Product Change Notification

PCN-ICC-8213-2022

Business Unit	Product Line Code	Type of Change	Action	Date of Issue
ICC - Industrial Cabinet	BE1	Product Change Notification	Notify Distributors and Field	8/23/2022

Previous Product	New Product
 old	 new
 old	 new

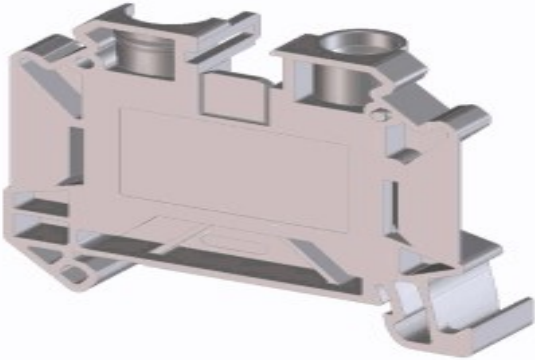
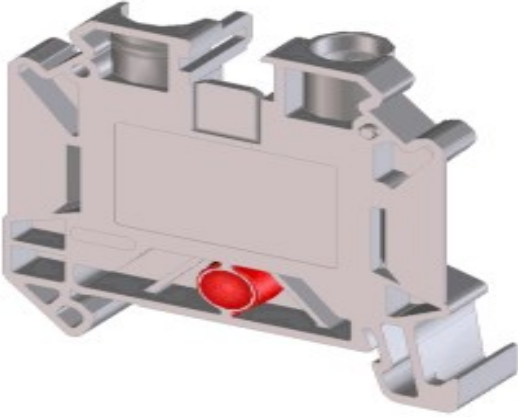
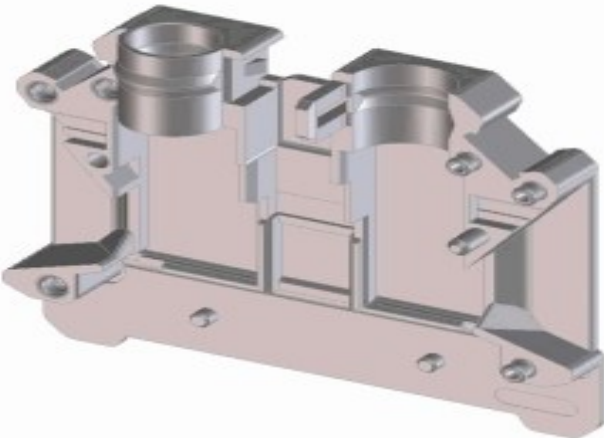
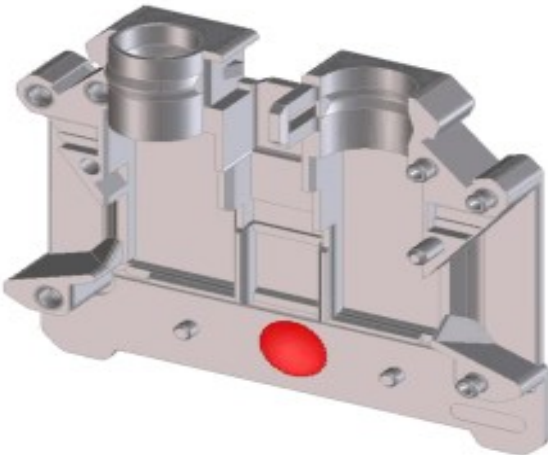
Due to the manufacturing processes, the housing will be slightly modified. The old injection molding tools have almost reached the end of their service life, so new injection molding tools will be implemented in the processes. This also means switching from a cold runner to a hot runner system, which will result in a slight change in the visual appearance of the housings. The changes can be determined based on the production batch in the item list.
